**DATA SET 202C-TYPE
TRANSMITTER-RECEIVER
CONNECTIONS**

1.001 This addendum supplements Section 592-015-400, Issue 3. The attached page must be inserted in the section in accordance with filing instructions above.

Fig. 3—Two-Wire Switched Network Using Data Auxiliary Set 801-Type

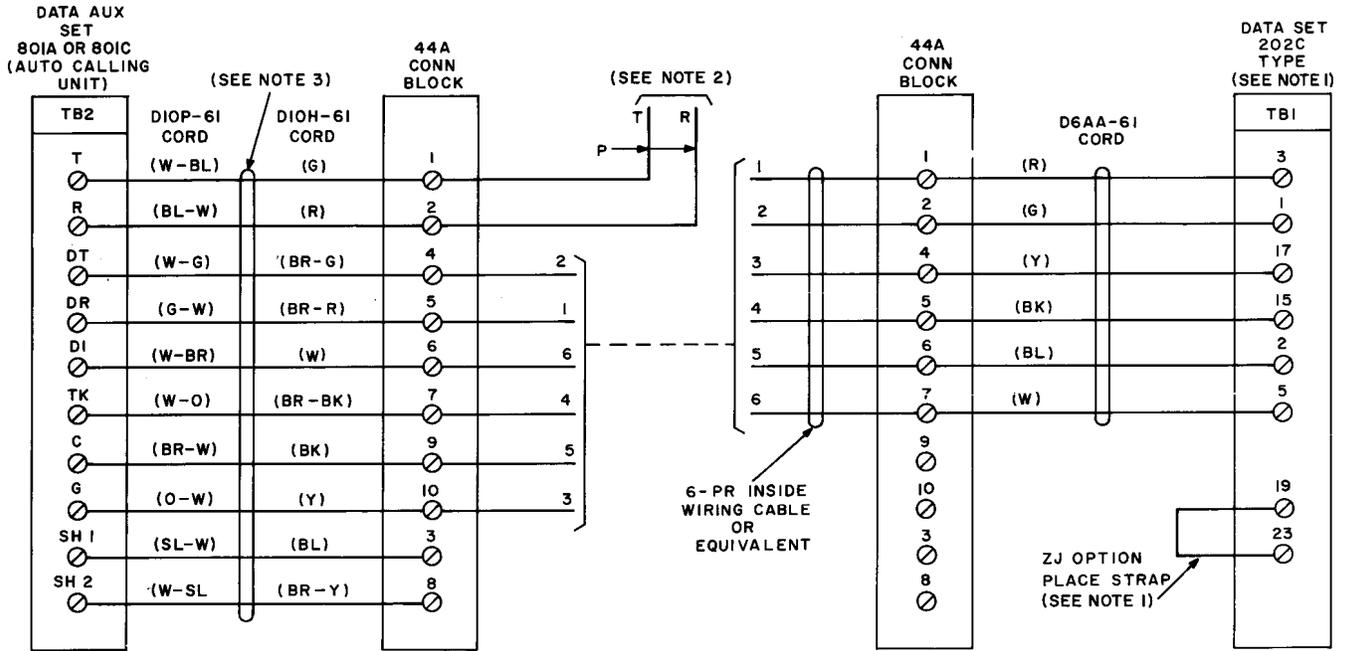
1.002 This addendum is issued to revise Fig. 3. A new cord (D10P-61) is shown for ACU connections and information concerning ground and loop start is added to the notes.

1. FOR GROUND START ACU, ADD DESIGNATION-DIAL TONE-IN SPARE 1 POSITION ON KEY DESIGNATION STRIP. STRAP IS STORED AT TBI 17 AND 20. THE BUTTON MUST BE NONLOCKING. THIS BUTTON AND THE ZJ STRAP ARE NOT REQUIRED WITH A LOOP START ACU.
2. WITH 801A-TYPE ACU, CONNECT T AND R TO CO OR PBX LINE ARRANGED FOR GROUND START OPERATION. WITH 801C-TYPE ACU, CONNECT T AND R TO CO OR PBX LINE ARRANGED FOR "TOUCH-TONE" DIALING. THE 801C-TYPE CAN BE USED ON EITHER LOOP OR GROUND START OPERATION.
3. THE DIOP-61 CORD REPLACES THE DIOH-61 CORD WHICH HAS BEEN MD'D.
